# CITY OF ALBUQUERQUE

RE: **Lot 10 Block 1 Volcano Cliffs Unit 22 SAD 228  
8008 Alto Rey Ct. NW  
Grading and Drainage Plan  
Engineers Stamp Date 10/21/2020 (D10D003N10)  
Pad Certification Dated: 5/10/2021**

**Re: Pulte at Volcano Cliffs Unit 18  
Erosion and Sediment Control Plan  
Engineer's Stamp Date 6/17/2021 (D10E003\_P)**

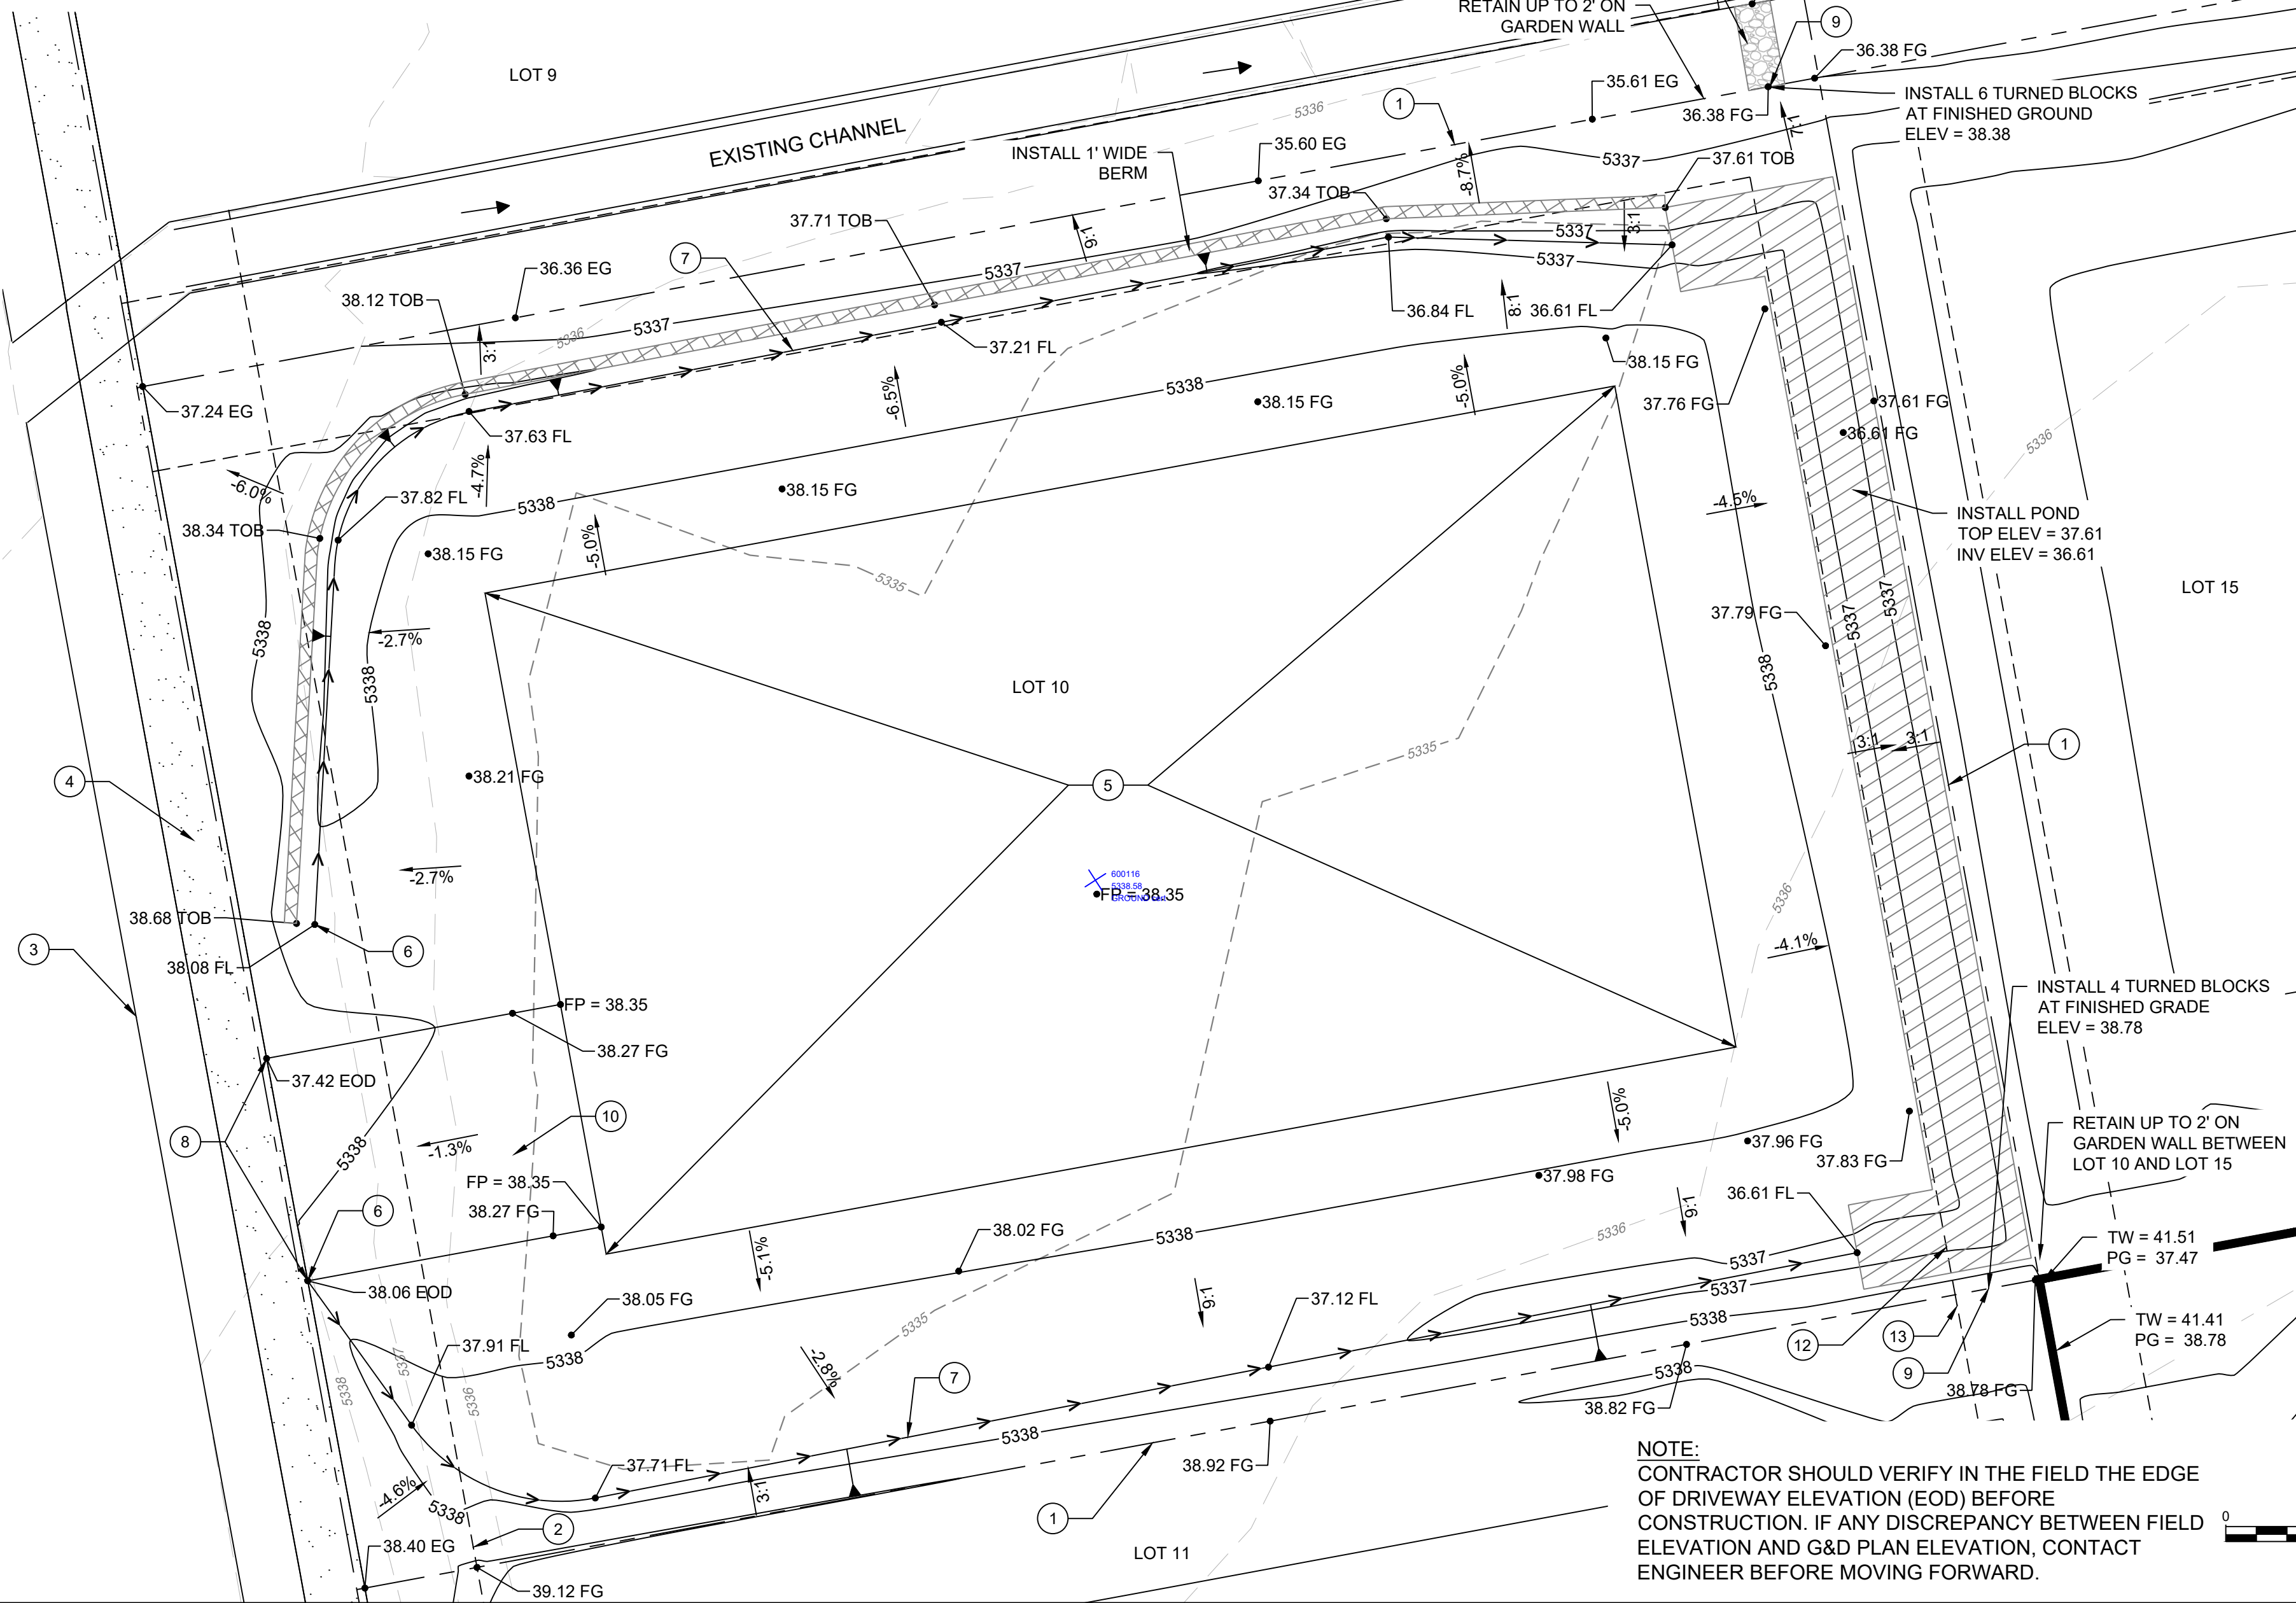
Based upon the information provided in your submittal received 6/25/2021, this plan is approved for Building Permit.

Reiterate to the Owner/Contractor that a separate permit for a garden/retaining wall must be obtained with the approved G&D plan and Pad Certification. **Also, if a swimming pool is to be placed the grading and drainage plan will change and will need to be resubmitted showing location of pool and land treatment changes.**

**Prior to Certificate of Occupancy release, Engineer Certification per the DPM checklist will be required.**
